**MAINE DEPARTMENT OF
INLAND FISHERIES AND WILDLIFE**

ADDENDUM NO. 1

**IMPROVEMENTS AT GRAND LAKE STREAM STATE FISH HATCHERY
GRAND LAKE STREAM, MAINE**

BGS PROJECT NO.: 3289-14

UPPER PAVILION DOOR SCHEDULE AND DETAILS

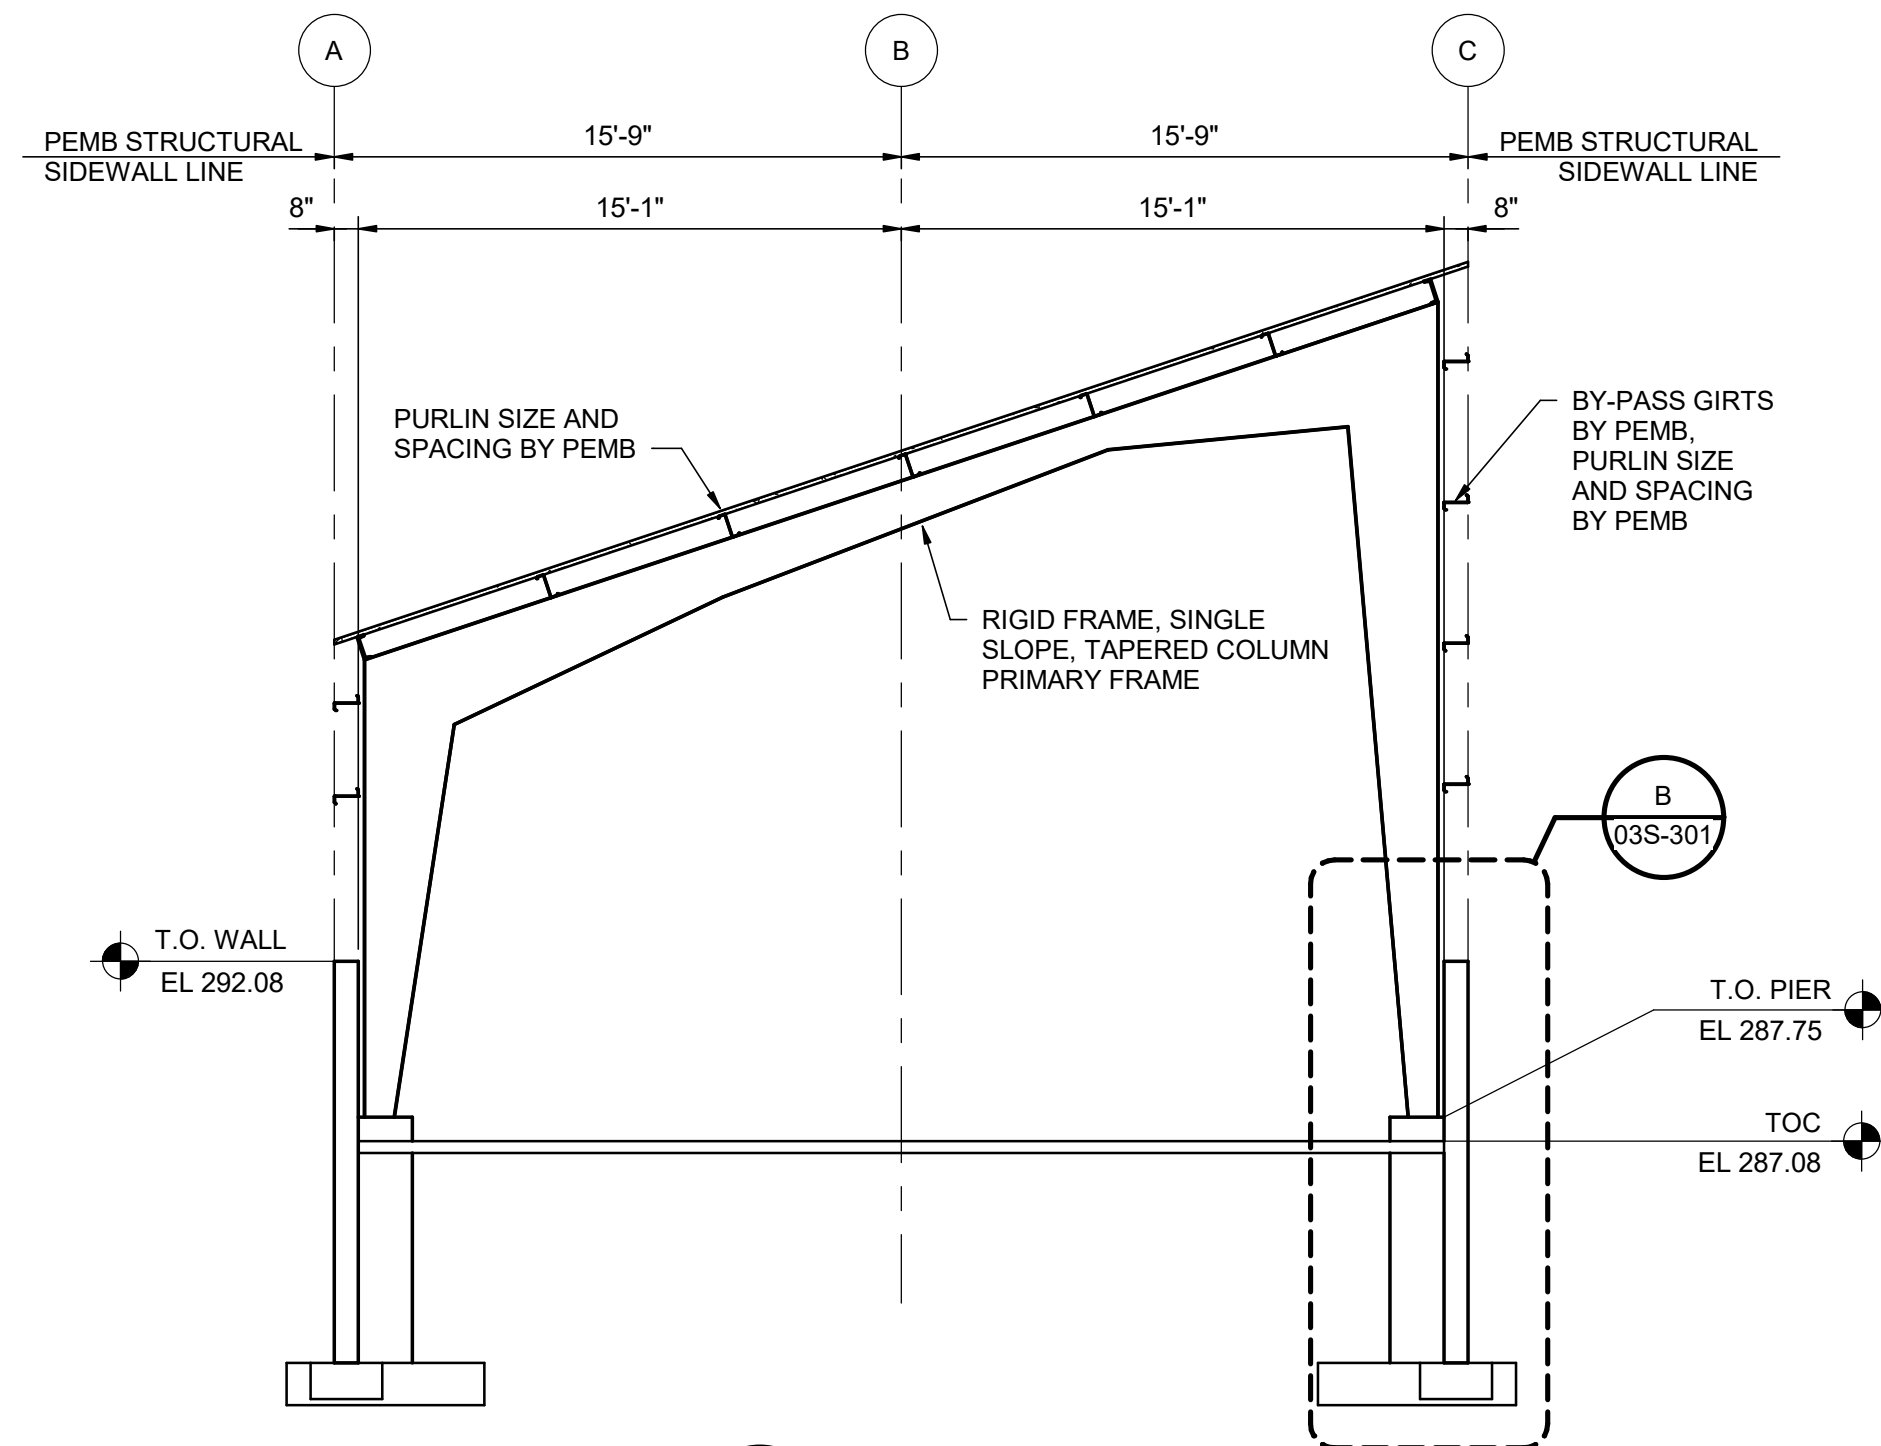
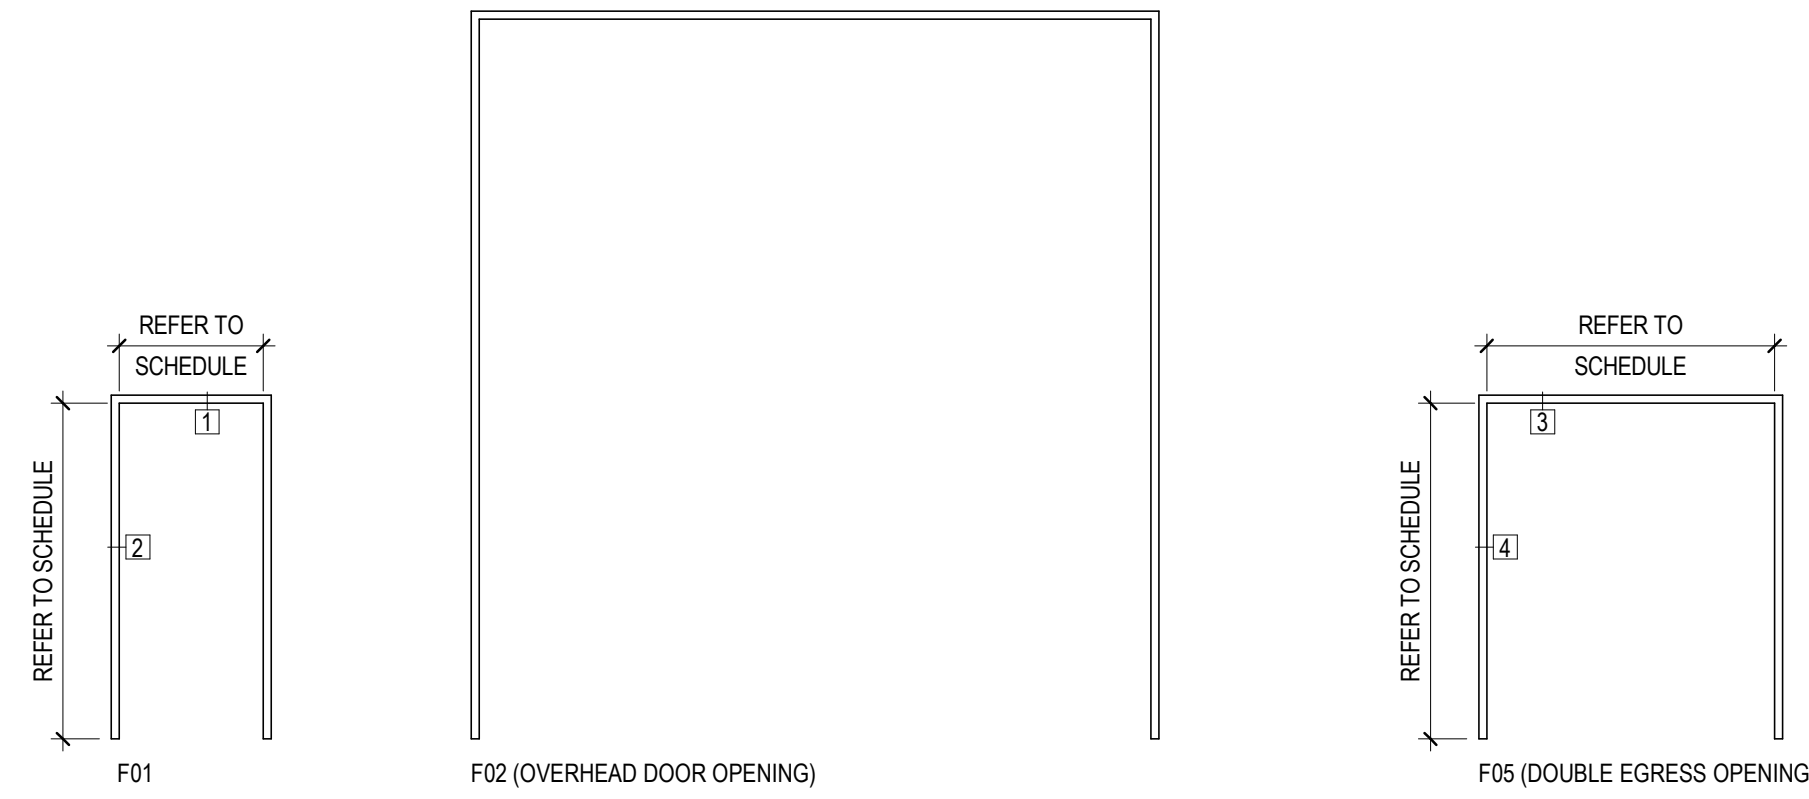
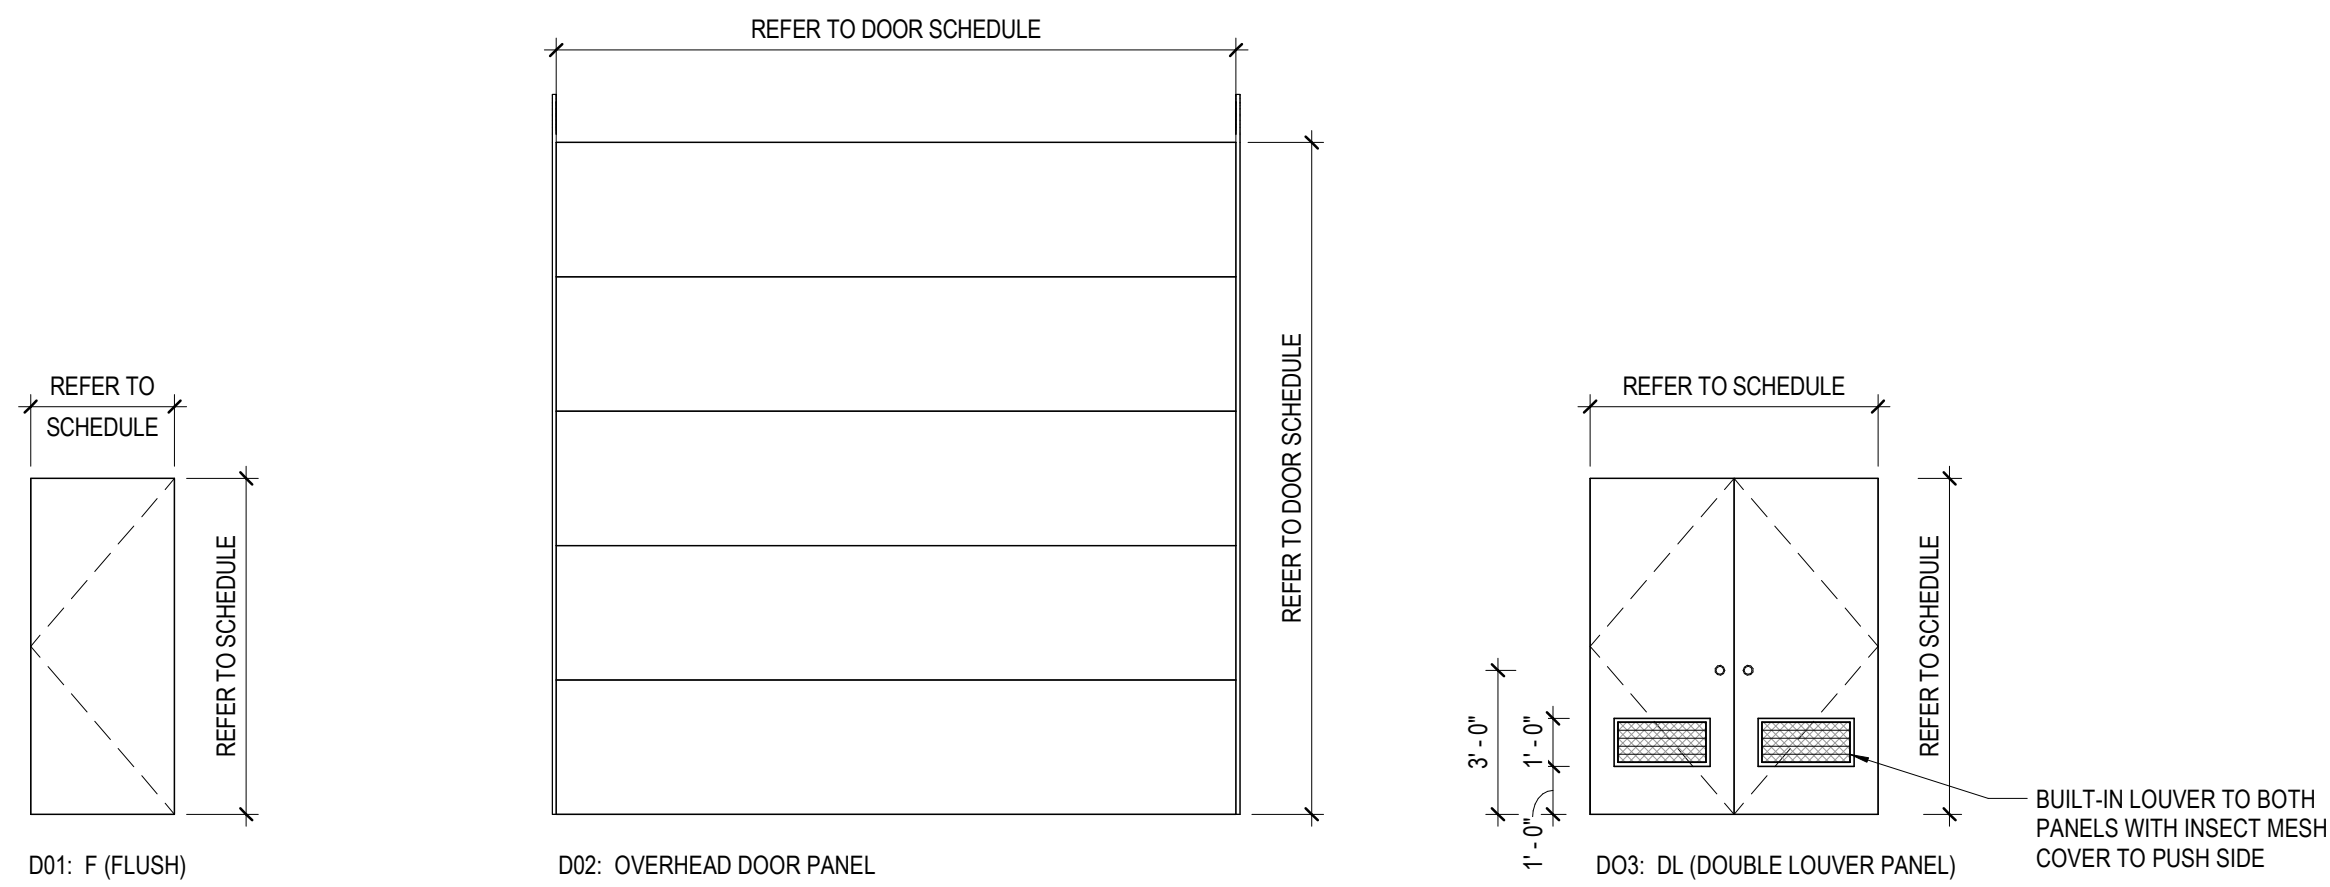
***UPDATE:** Sheet was updated to modify the door and frame schedule to update the feed storage garage height to 8-ft.*
